**BOARD OF ZONING ADJUSTMENT
STAFF REPORT****Date: June 4, 2017****CASE NUMBER**

6178

VARIANCE REQUEST

PARKING SURFACE: Surfacing Variance to allow aggregate surfacing for a proposed RV park in a B-3, Community Business District.

SITE PLAN

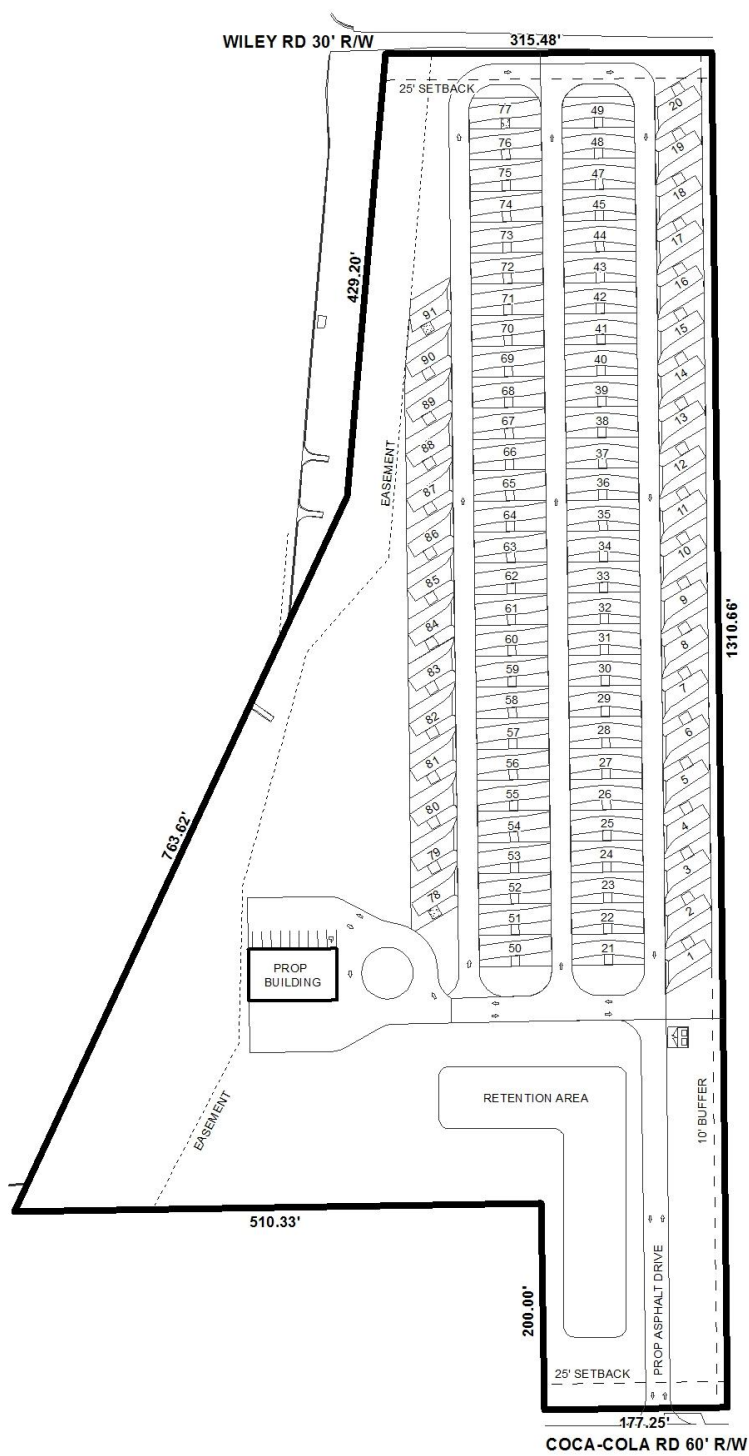
If a surface variance is approved, the aggregate cannot extend into the right-of-way and cannot be used in the areas designated as the accessible path from any required handicap space to the building. Specific to this site, parking stops/bumpers should be considered for the exterior parking stalls to prevent vehicles from encroaching into the landscaped areas.

The site plan illustrates both of the proposed phases of development of the recreational vehicle park. As mentioned, 91 off-street recreational vehicle parking spaces are proposed, the dimensions of which vary in two (2) ways: Type A, which will be 52.26' in length with 43.46' of frontage along a proposed drive aisle; and Type B, which will be 70' in length with two (2) 23.4'-wide frontages along two (2) proposed drive aisles. Each space will be equipped with a 2' X 9' concrete pad for utility connections, and a concrete patio – 10' X 10' for Type A spaces, and 8' X 10' for Type B spaces. Additionally, each space will be developed with a concrete apron providing access to a gravel-surfaced parking spot for each recreational vehicle, per drive aisle frontage. It was noted in the Planning Approval and Subdivision staff report, however, that gravel surfacing is not an approved surfacing material in a B-3, Community Business District and, as such, the site plan could either be revised to illustrate recreational vehicle parking spaces surfaced in either concrete, asphalt or other approved surfacing material should be required; or, the applicant could seek Surface Variance Approval by the Board of Zoning Adjustment to allow gravel surfacing in a B-3, Community Business District, hence the application at hand.

Access to and around the site will be via paved asphalt drives, at least 20 feet in width. Each proposed aggregate RV parking space will abut an asphalt drive.

It should be noted that the aforementioned one-way turnaround at the club house is illustrated as having a diameter of 50'. The applicant should verify the minimum turnaround diameter with the Fire Department and adjust the plan if necessary.

- 1) coordination with the Fire Department to ensure adequate site circulation and revise the site plan, as necessary;
- 2) compliance with Engineering comments: *(If the aggregate surfacing is approved for use the applicant will need to have the following conditions met: a. Submit and receive a Land Disturbance Permit for the proposed site development through Central Permitting. b. Submit a ROW Permit (City of Mobile) for the work within the Public ROW. Aggregate surfacing will NOT be allowed within the public ROW. c. Designated handicapped accessible spaces and routes must be paved (concrete, asphalt)..);*

- 3) compliance with Traffic Engineering comments: *(If a surface variance is approved, the aggregate cannot extend into the right-of-way and cannot be used in the areas designated as the accessible path from any required handicap space to the building. Specific to this site, parking stops/bumpers should be considered for the exterior parking stalls to prevent vehicles from encroaching into the landscaped areas.);*

- 6) provision of the revised site plan to the Planning and Zoning Department prior to the approval of any permit requests; and,
- 7) compliance with applicable Codes and Ordinances.
